ADDENDUM NO. 2

PROJECT: **Village of Gurnee Public Works Material Bin Reconstruction Project 2024**

1. Revisions to plan sheet S1-1 and clarifications to the Plans and Project Manual.

1 FOUNDATION PLAN
1/8" = 1'-0"
NORTH

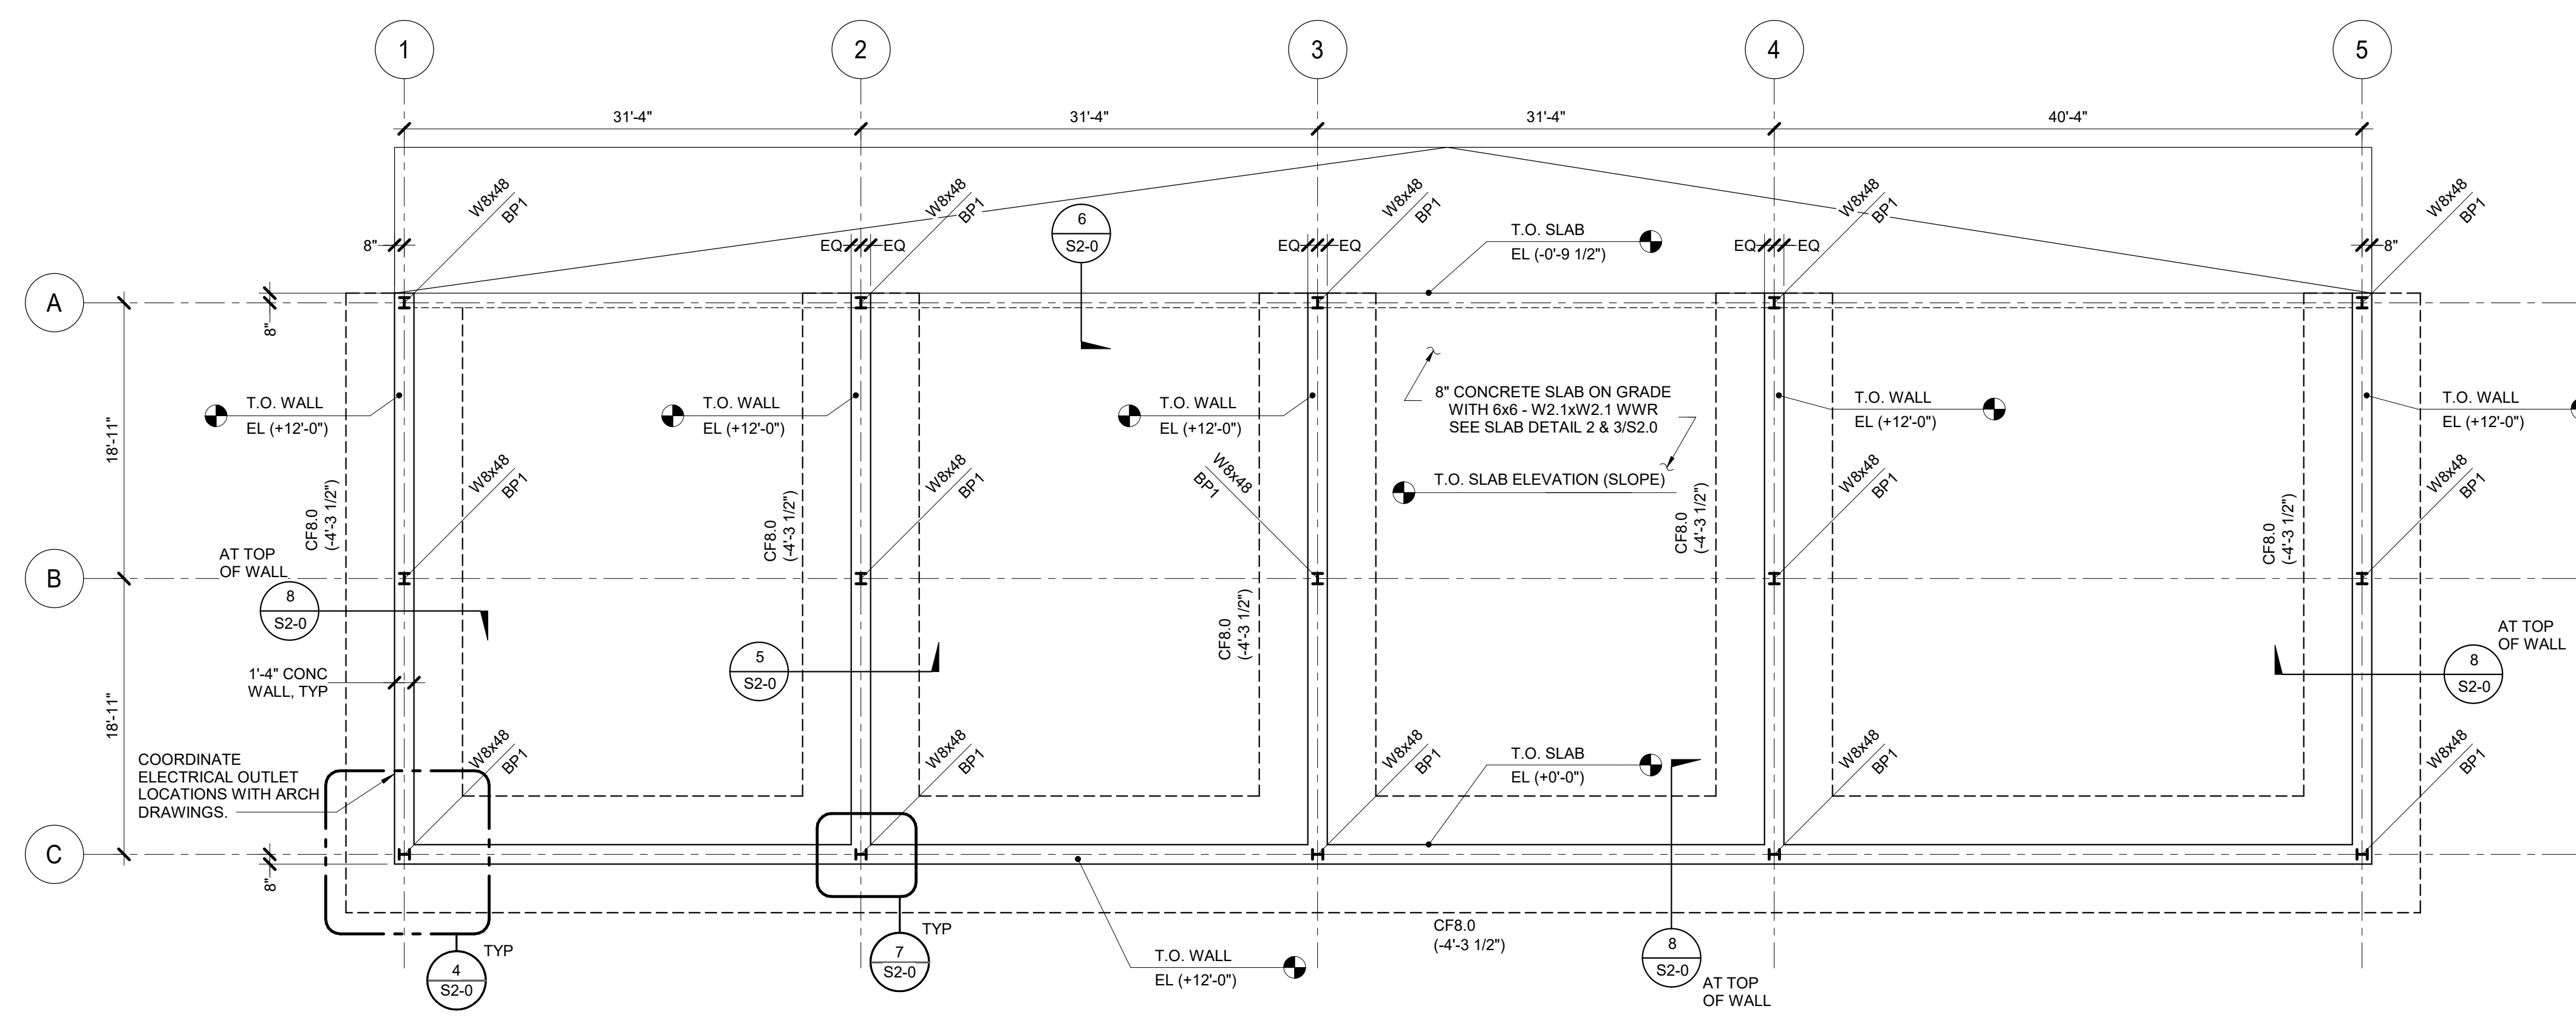
- **QUESTION:** Will you consider an alternate bid where columns are set on top of the concrete wall as opposed to the scheduled columns set on footing and then encased in the concrete wall?
- **RESPONSE:** This may be a misinterpretation of the drawings. The intent is for the column to sit on top of the wall. On the foundation plan, the top of wall is shown at (+12'-0") and the column on that. We are not asking for encasing the column in concrete for this project.

2 ROOF FRAMING PLAN
1/8" = 1'-0"
NORTH

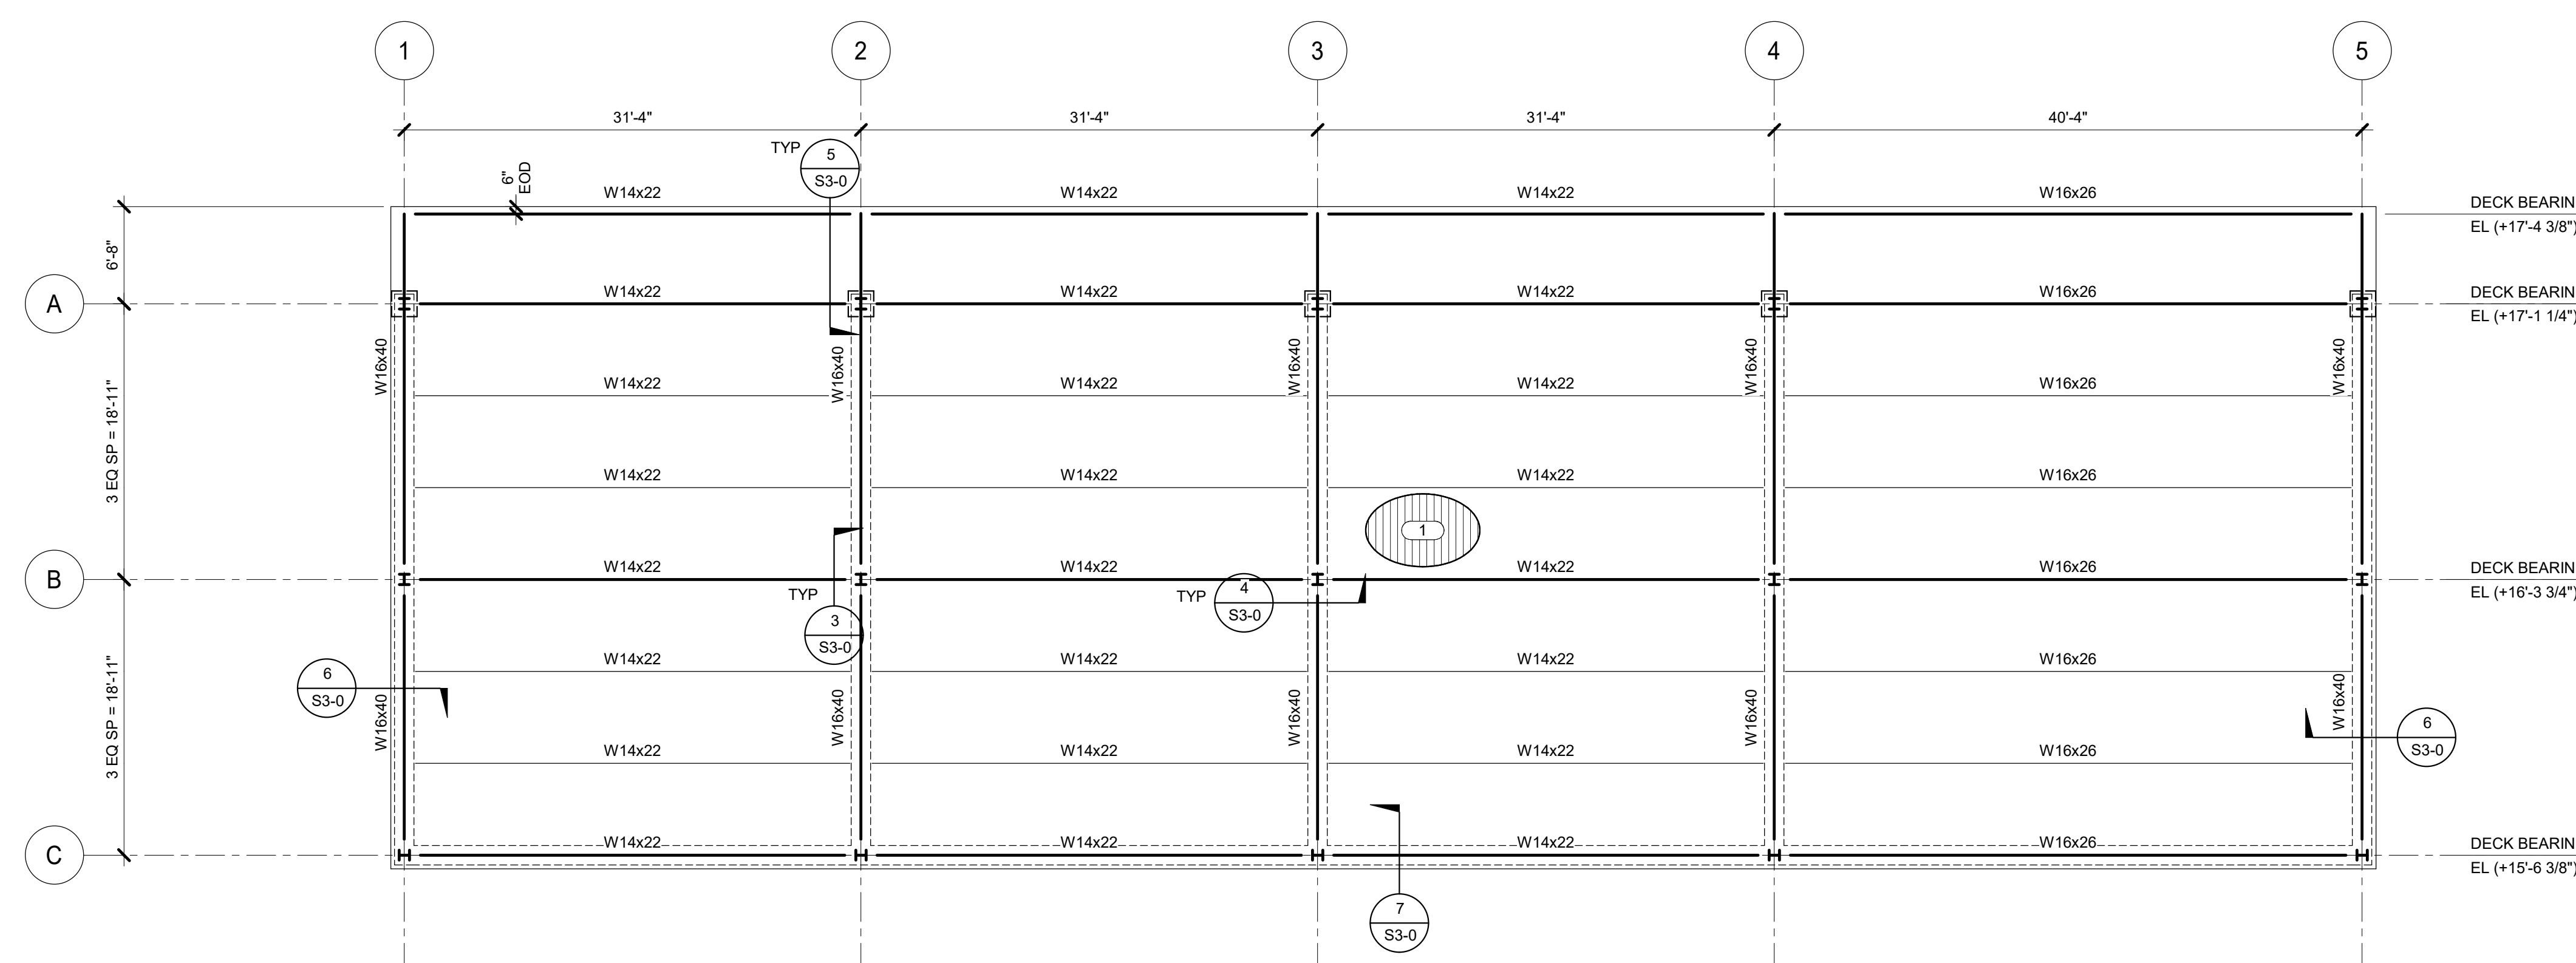
- **QUESTION:** Please clarify keynote #1 on 2/S1-1 "Deck to be fully galvanized" Does this indicate something different than using the standard galvanized metal deck provided by the manufacturers?
- **RESPONSE:** No, this is the standard galvanization that comes from the shop.

- **QUESTION:** Please confirm that the roof deck attachment is to be completely screwed down.
- **RESPONSE:** Deck attachment is #12 Tek screws at support with #10 Tek screws for the sidelap fasteners.

- **QUESTION:** Metal decking Tek screws as noted for attachment in keynote #1 on 2/S1-1 will not necessarily create a water tight barrier. Any penetrations through the deck will be potential locations for water leaks, and rusting to occur if left exposed. Please confirm.
- **RESPONSE:** Replace plan sheet S1-1 with revised plan sheet that now calls for a welded connection.

KEYNOTES: (#)
1. 1/2" (20 GA) TYPE B STEEL ROOF DECK. FASTENING PATTERN IS 3/8" WITH 5/8" DIAMETER PUDOLE WELDS AT SUPPORT AND (1) #10 TEK SCREWS PER SPAN AT SIDELAPS. DECK TO BE GALVANIZED.
